E3630A-03E-S

S E R V I C E N O T E

E3630A - Manual DC Power Supply

POSSIBLE SHOCK HAZARD

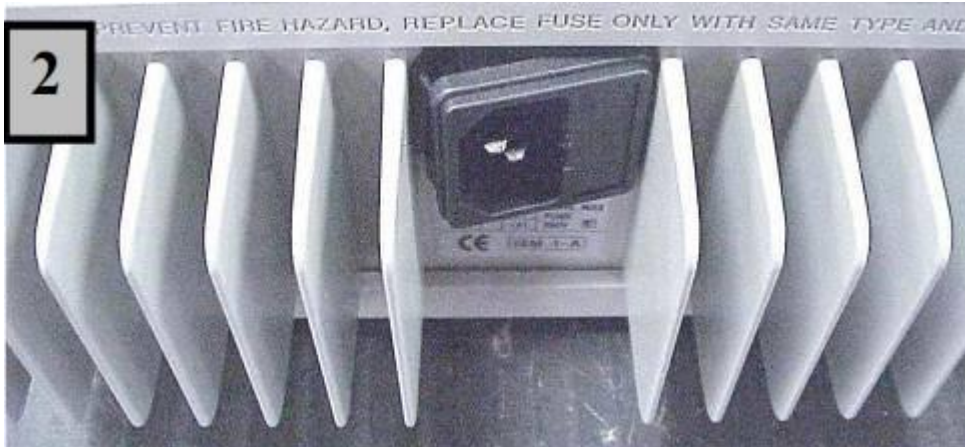
If the AC line cord is forcefully pulled in a side-to-side direction the AC module can be pulled out of the rear heat sink, exposing the conductors that carry AC line voltage.

LOOSE AC MODULE

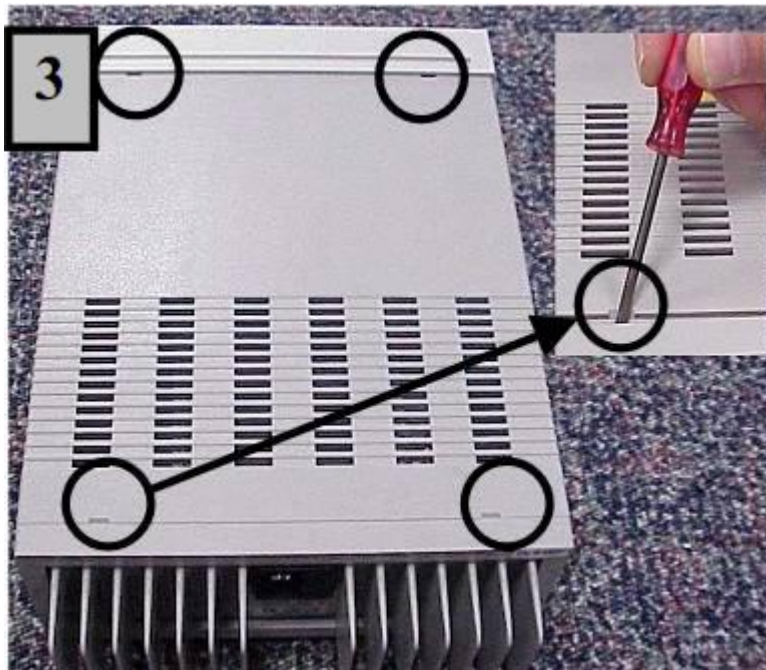
1. Make sure line cord is removed from outlet.
2. With line cord securely inserted in AC module as shown, pull forcibly (2 times) in direction of arrow.

1. If the AC module pulls out from unit as shown it will need to be replaced.
2. If the AC module remains in place it does not need to be changed. Put a mark on the AC input label in the lower left hand corner with indelible ink to indicate that AC module has been checked. This label can be found below the AC module.

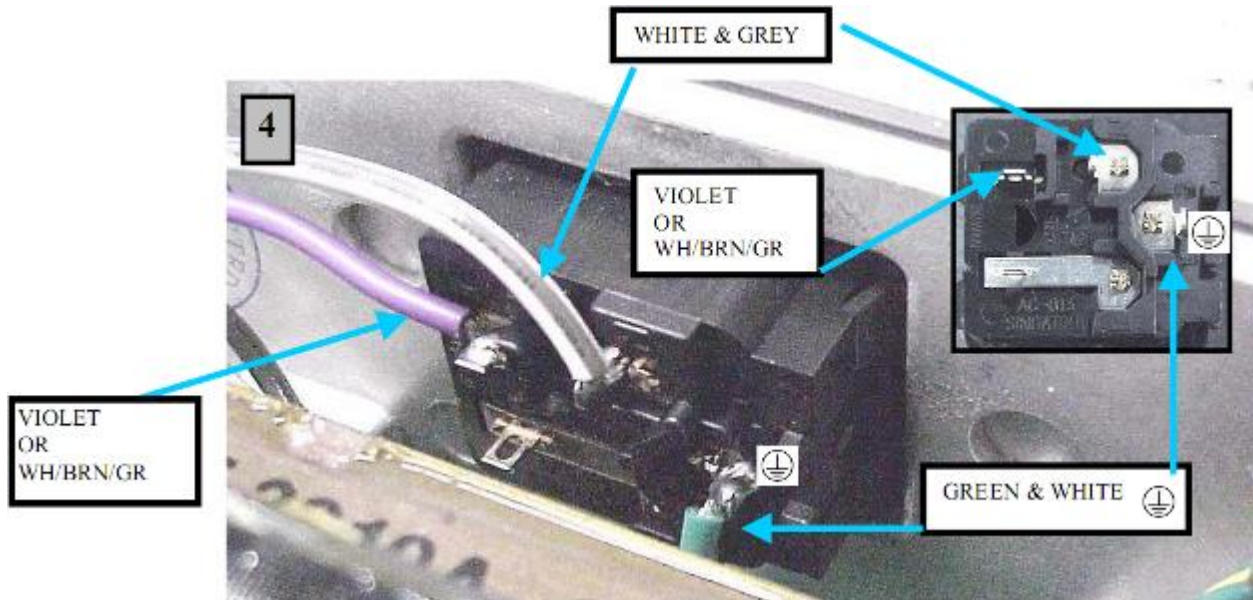
REMOVE COVER by prying rear bezel and front panel away from cover in four places as shown. Then lift cover off unit.

REPLACE MODULE with P/N 5065-6978. Before soldering perform “TEST FOR LOOSE AC MODULE” as shown in the picture above. This will confirm that the new module is secure. Solder wires and **REPLACE FUSE**.

CAUTION: WIRING MUST BE CORRECT OR HEAT SINK COULD BE AT LINE POTENTIAL.

CAUTION: MAKE SURE SAFETY GROUND  IS ATTACHED TO HEAT SINK.
